SAFETY RECALL NOTICE

Glaval Bus a Division of Forest River, Inc. 914 County Road 1 North, Elkhart, Indiana 46514

This recall applies to the Delphi Corporation Pack Con II fuse holder, contained within the EM1 evaporators.

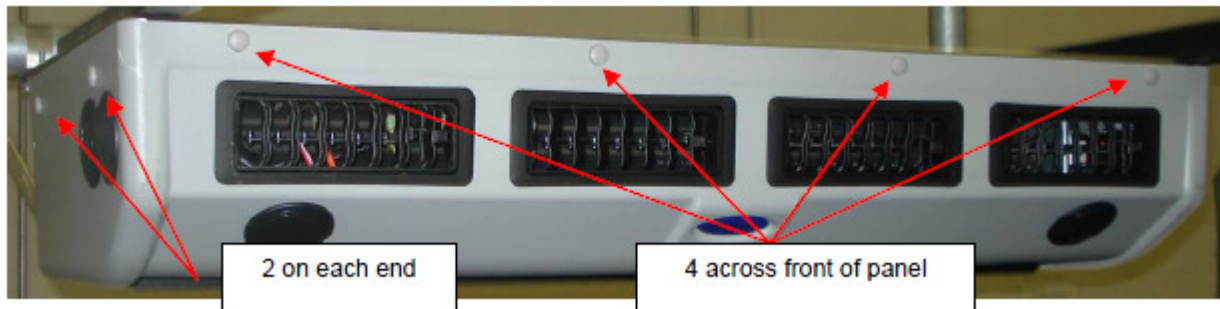
STEP 1) Remove the cover from the evaporator by removing the 8 screws shown below. Properly support the cover while removing the screws.

STEP 2) Once the cover has been removed, the identification tag containing the unit part number, manufacture date, and serial number can be found on the motor "cradle" mount, as seen in the photo below (on left). Compare the information to the above mentioned manufacture date, and/or serial number. Units employing a fuse holder as appears circled in red below require the upgrade with the new fuse holder.
